**NEW MILLENNIUM PROJECT CONFIGURATION CHANGE REQUEST**

<b>PROGRAM</b> <u>EO-1</u>	<b>TITLE</b> CHANGES TO EO-1 WARP TO AC ICD-57		
<b>CCR NO.</b> 0038	<b>ORIGINATOR</b> George Jackson		
<b>DATE INITIATED</b> 09/03/99	<b>ORIGINATOR'S CHG. NO.</b>		
	<b>SPONSOR/CODE</b> George Jackson	<b>PHONE</b>	x3255

<b>GODDARD SPACE FLIGHT CENTER</b>		<b>GODDARD SPACE</b>	
PRELIMINARY SPECIFICATION CHANGE NOTICE (PSCN) No. _____		PAGE 1 OF 2	2. INIT. DATE: 9/2/99
or PRELIMINARY INTERFACE REVISION NOTICE (PIRN) No. 001		3. CONTRACT NUMBER	
4. ASSOCIATED CONTROL NUMBERS: <b>EO-1CCR 0038</b>	5. CI'S AFFECTED: WARP TO AC ICD-057	6. DOCUMENT NUMBER: REVISION:

12. Add: The following Diagram 2.4

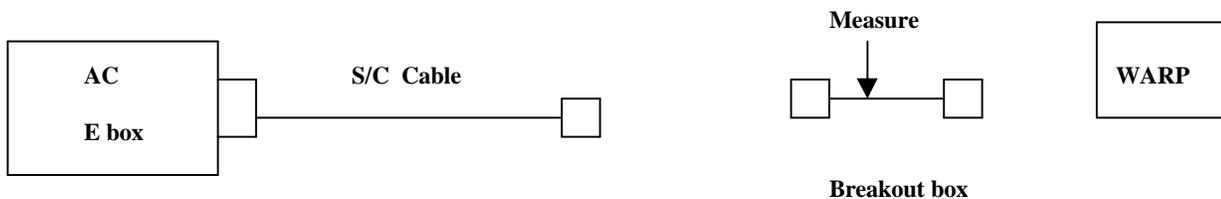
10. Add: The following section 2.5.4.1 **Setup Time:**

**The minimum set up time at room temperature for the 3 MHz frame rate shall be 50ns. The minimum setup time at room temperature for the 6 MHz frame rate shall be 25ns. All measurements shall be taken at the breakout box as shown in figure 2.4.**

11. Add: The following section 2.5.4.2 **Hold Time:**

**The minimum hold time at room temperature for the 3 MHz frame rate shall be 50ns. The minimum hold time at room temperature for the 6 MHz frame rate shall be 40ns. All measurements shall be taken at the breakout box as shown in Fig. 2.4**

~~To: The low level output voltage of transmitted signals is 0.5 V maximum.~~ The high level output voltage of transmitted signals **shall be greater than is 2.5 V minimum.** **The low level output voltage measured across differential pairs shall be less than -2.5 volts measurements will be taken at breakout box where shown in Fig 2.4**
